**Medway Planning & Economic Development Board  
Meeting**

**Public Hearing Continuation**  
**Medway Place Shopping Plaza Site Plan**  
**98, 108 and 114 Main Street**

**SUPPLEMENTARY SITE PLAN SUBMITTAL**  
**July 14, 2021**

**MEDWAY REALTY, LLC**  
**SITE PLAN REVIEW APPLICATION DATED OCTOBER 28, 2019**

**SITE PLAN &  
LANDSCAPE  
PLAN**

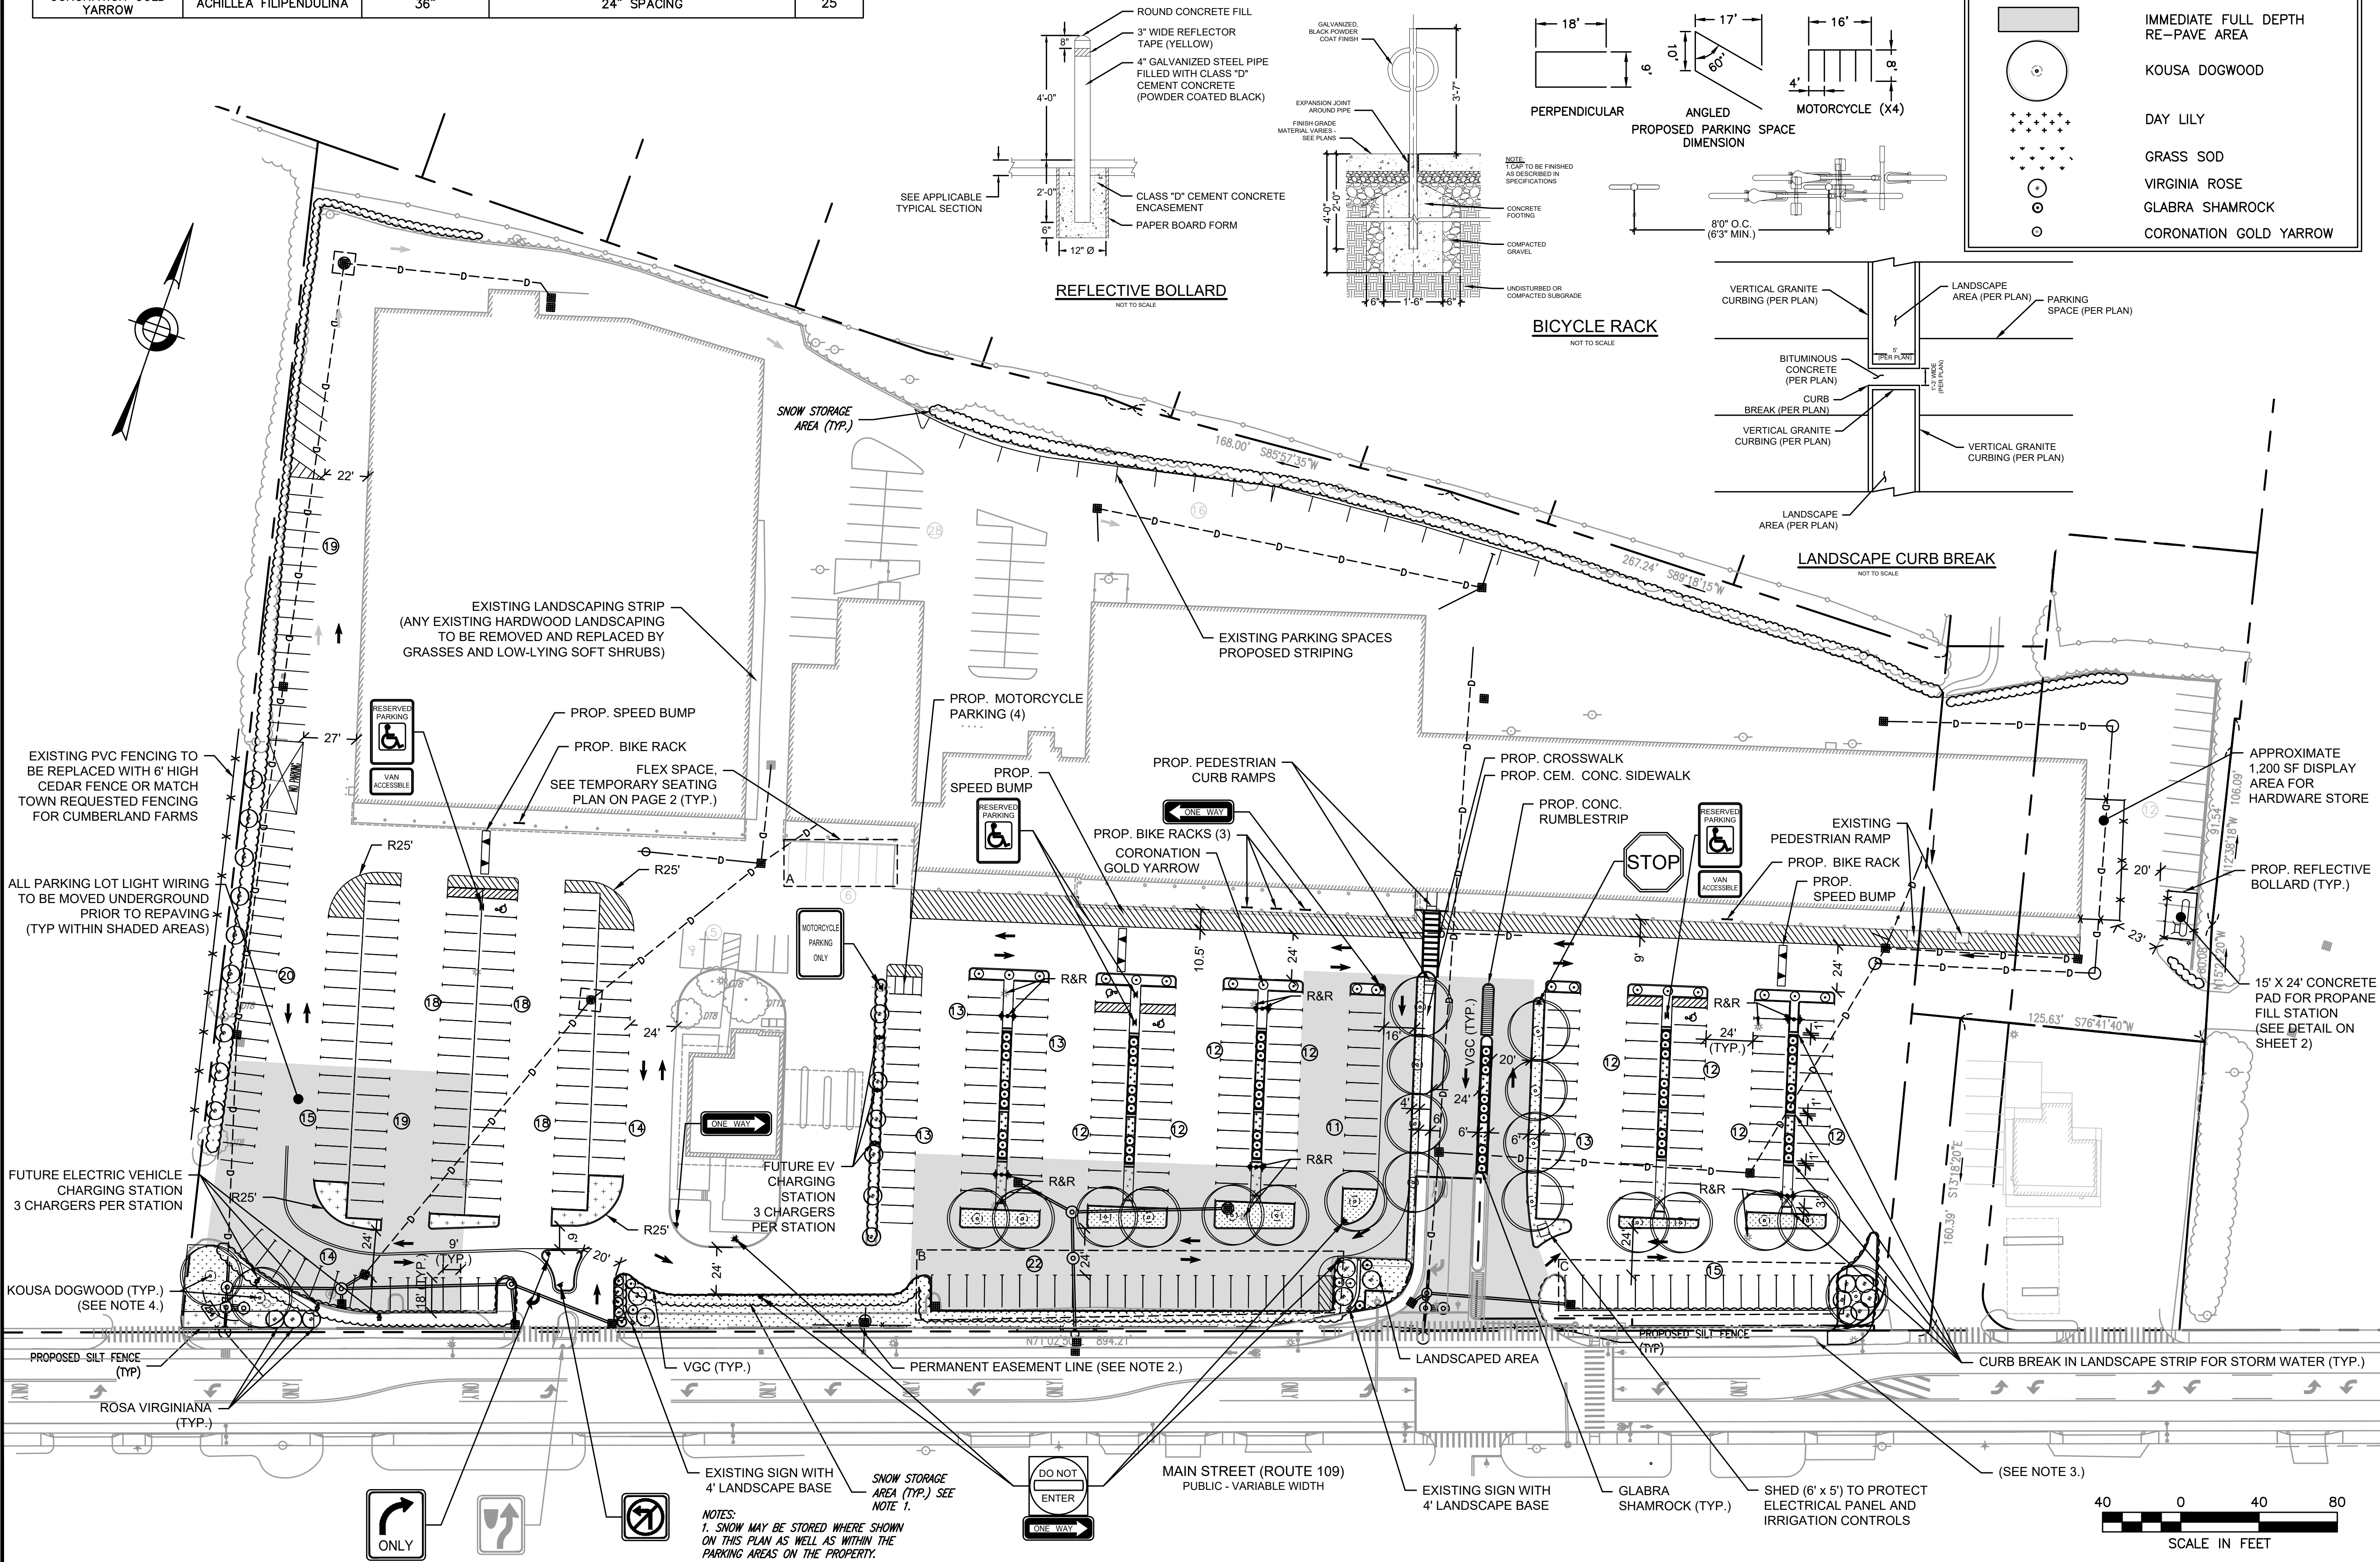
8. **Section 207-19-B(2) requires perimeter landscaping around the entire site. The plan now shows perimeter landscaping along most of the Main Street frontage. The areas are labeled as “Landscaped area”, but details of the landscaping are not provided.**

9. **Section 207-19-C(1)(a) requires that a minimum of 10% of internal parking area shall be provided as landscaped island areas, exclusive of perimeter landscaping. 207-19-C(1)(b) requires landscape islands at the ends of rows with more than 15 parking spaces. ... Section 207-19-C (1)(d) requires at least 1 deciduous shade tree per 6 parking spaces. ... The plan says there are 433 spaces so 72 trees would be required. There are 22. The parking rows now have landscaped islands except for the three rows in front of Ocean State Job Lot. The applicant says that contractual obligations preclude the islands at these locations.**

**5. Consider whether the trees near the main entrance provide enough clearance for the Fire Department.**

**6. Please provide some details for the landscaping around the sign.**

**13. Please provide more information on snow management.**

**RESPONSE:** The Revised Site Plan includes substantial landscaping in light of the existing conditions and shows what plants and flowers will be planted in these areas.

**RESPONSE:** Medway Realty believes that the proposed landscaping, consisting of 22 kousa dogwoods, raised landscape islands at the end of aisles except for those few aisle ends by Ocean State Job Lot, raised landscape areas between parking rows, and other features is appropriate given the reason for and the scope of changes in the parking lot. Medway Realty has not proposed raised landscape islands at the end of the parking rows near Ocean State Job Lot due to concerns with emergency vehicle access, not contractual obligations. However, the absence of trees in the portion of the parking lot that primarily serves Ocean State Job Lot is due to concerns with contractual obligations.

**RESPONSE:** Medway has replaced the honey locusts originally proposed with kousa dogwoods, which have a smaller canopy and are not likely to interfere with emergency vehicle access. In addition, Medway Realty would agree to a condition requiring that the kousa dogwoods be maintained so as not to interfere with emergency vehicle access through pruning and other appropriate practices.

**RESPONSE:** The Revised Site Plan shows additional details of the landscaping around the two monument signs. Due to the low clearance between the signs and the ground, this landscaping is limited to low-lying plants. As a result, Medway Realty proposes a mix of Virginia Rose, Glabra Shamrock, and Coronation Gold Yarrow.

**RESPONSE:** Snow storage areas are now shown on plans included with this submittal.

**TEMPORARY  
SEATING  
PLAN AND  
GATE DETAIL**

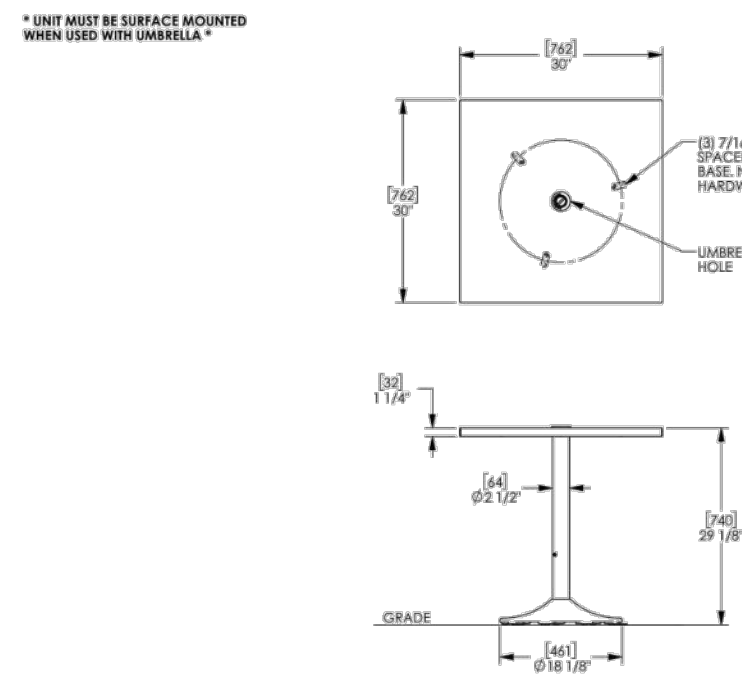
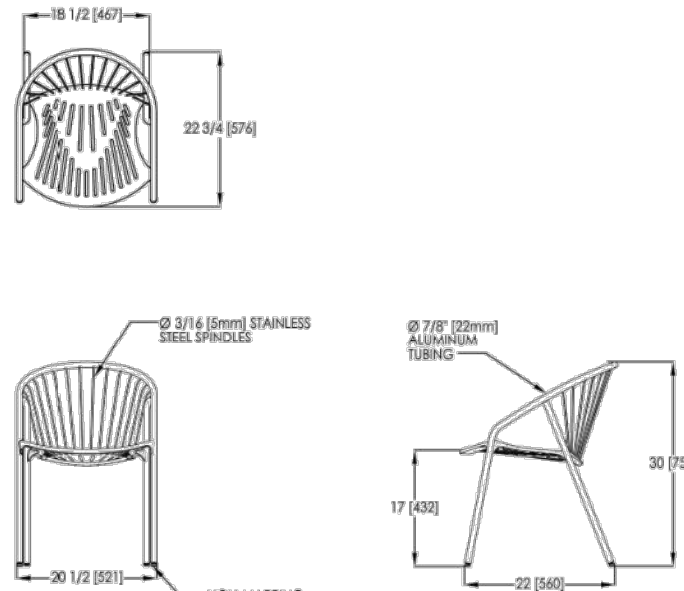
**7. Please provide information on how the outdoor seating areas will be buffered and protected from motor vehicle traffic.**

**RESPONSE:** As shown on the Revised Site Plan, Medway Realty will install large planters around the temporary outdoor dining spaces restaurant space that will protect the seated patrons and provide additional landscaping.
